Supplementary Environmental Impact Statement

Toms Gully Underground Project

July 2018

Figure 4: Showing an isometric of the Toms Gully Underground mine.

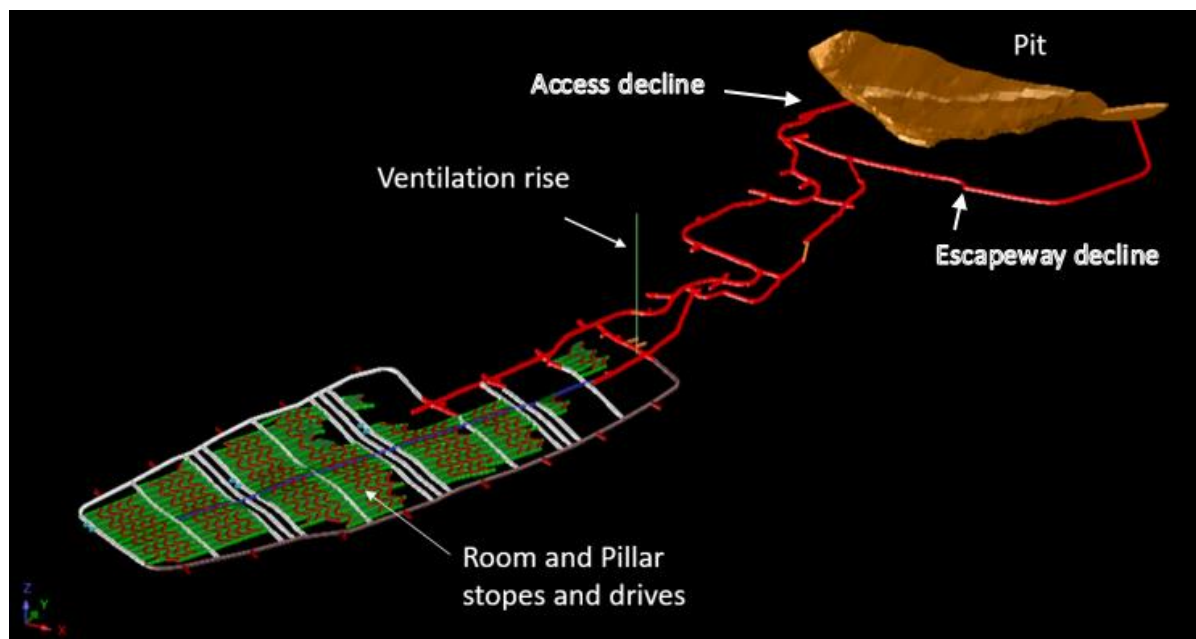
1. Outline design details, staging and depths of the underground mine.

Underground mining is proposed to commence in January 2020 after dewatering of the pit is complete. The underground workings are accessed from two declines in the existing pit (Figure 4). An access decline portal is at a depth of 96m below surface and the escape-way/ fresh air intake decline is at 65m below surface.
